Annex 10

Diagram 2

Towing vehicles and trailers

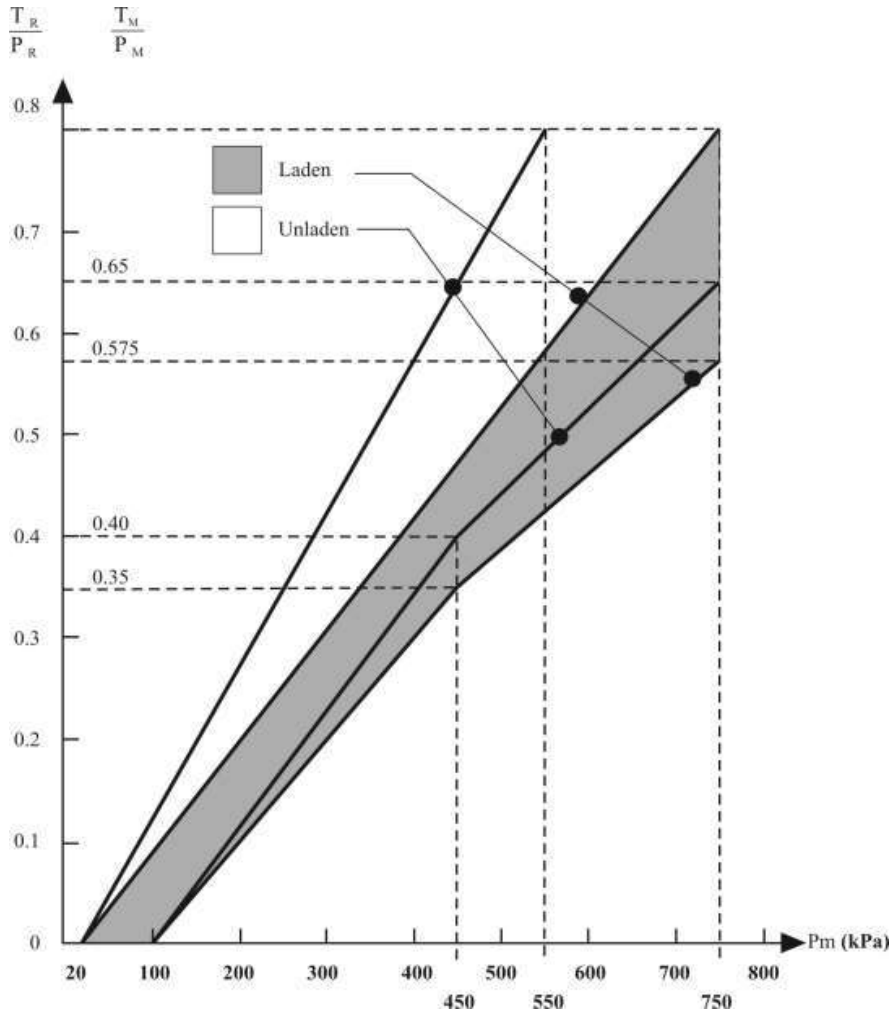
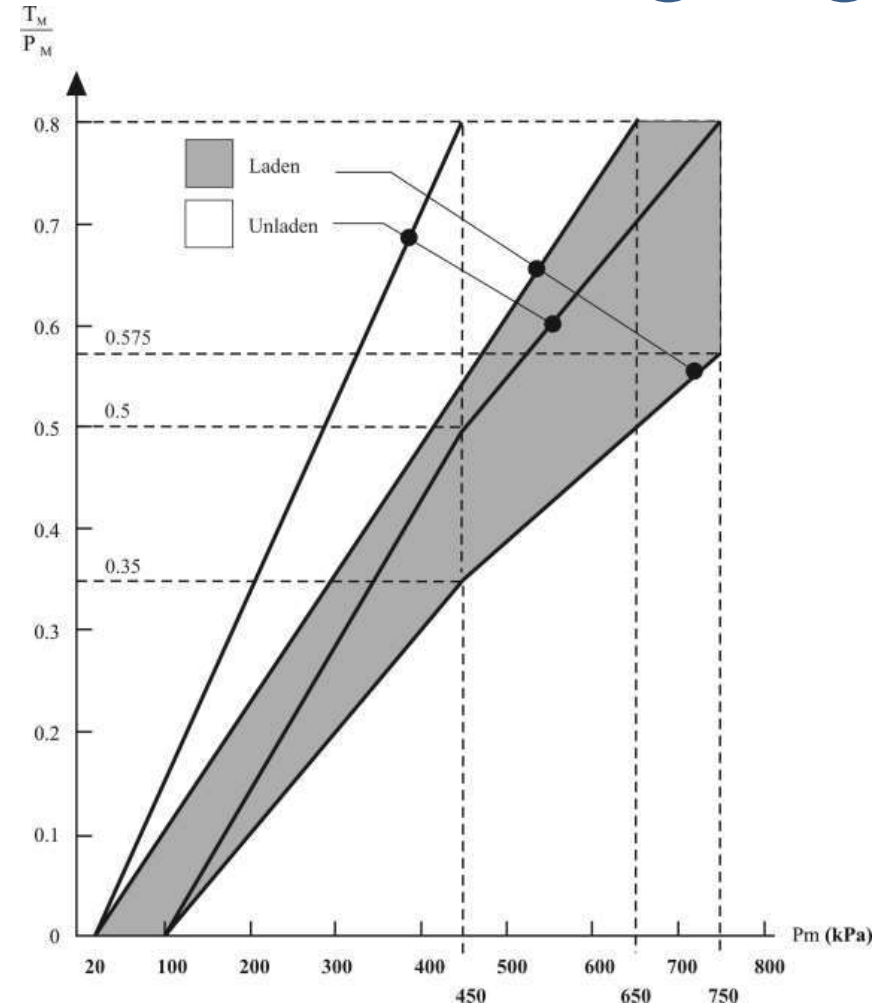
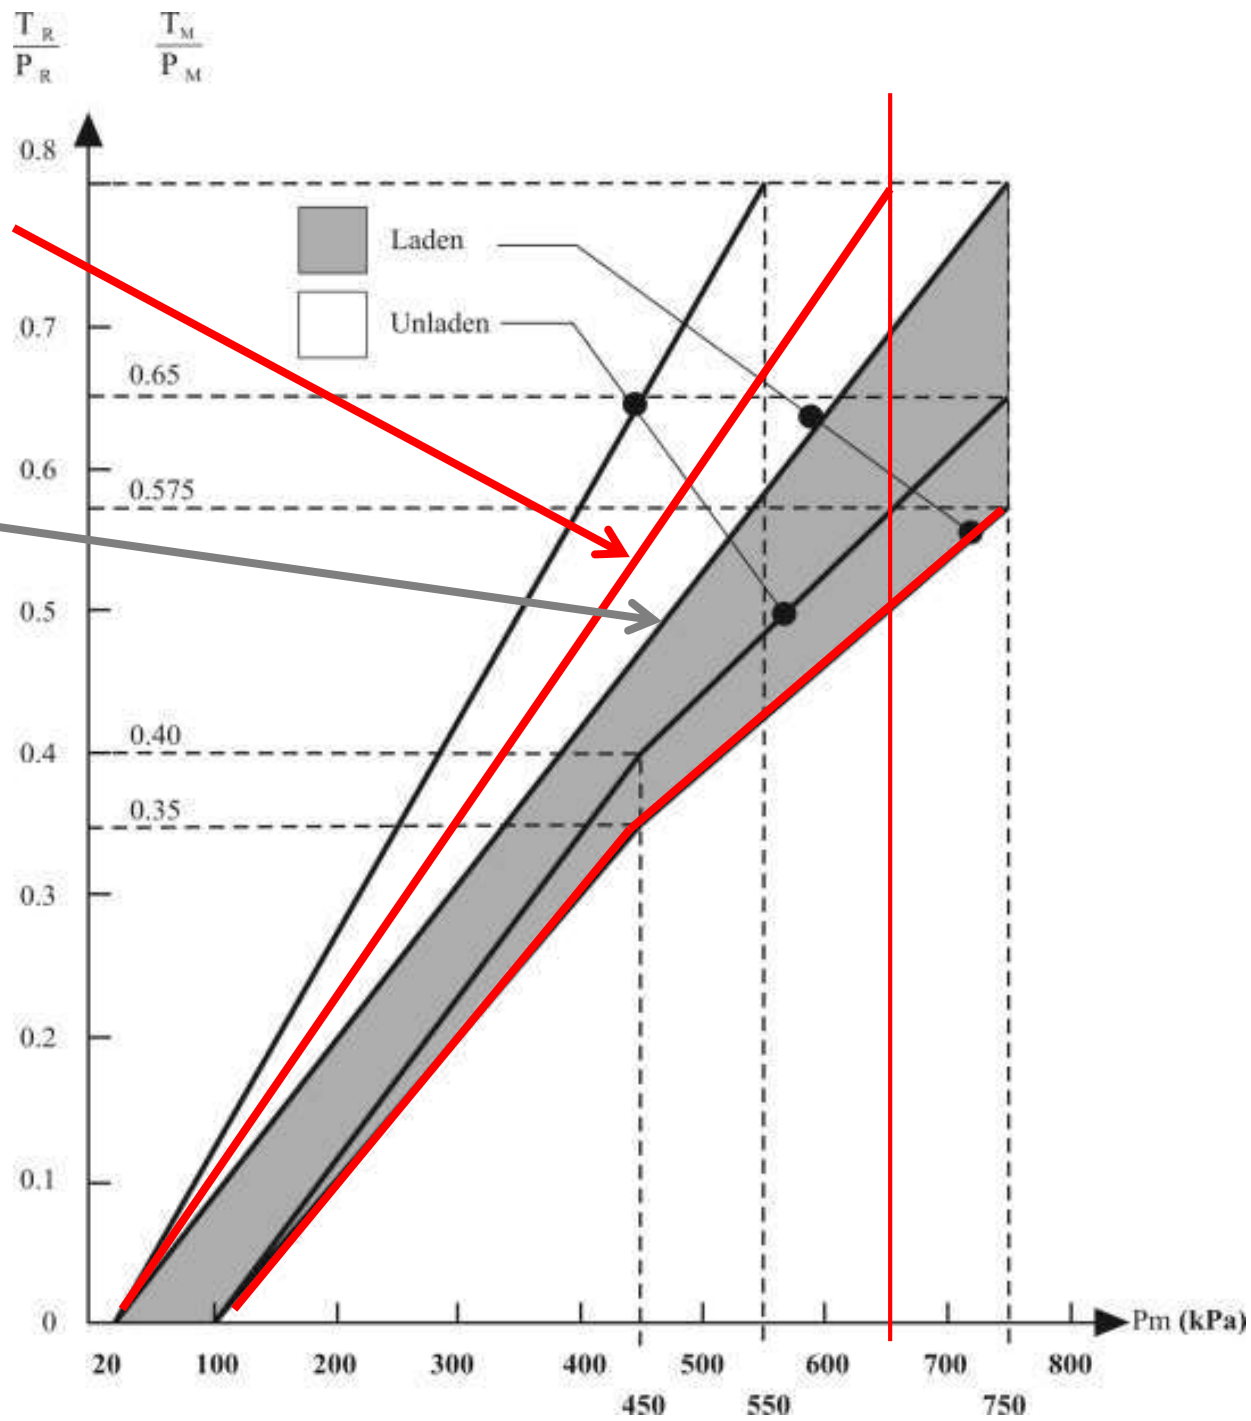
Type 0	50%	50%	50%	50%	45%		
				Same as tractor + semi-trailer. To be compared with performance of a full-trailer (50%) → do we have a proven calculation?			
Compatibility	Annex 10 Diagram 2 Towing vehicles and trailers	Annex 10 Diagram 2 Towing vehicles and trailers	Annex 10 Diagram 2 Towing vehicles and trailers X 0.95	Annex 10 Diagram 2 Towing vehicles and trailers X 0.95	Annex 10 Diagram 4A Semi-trailers		
				Are these 5% relevant for a dolly?

Both Dollies and tractors must be compatible with a semi-trailer
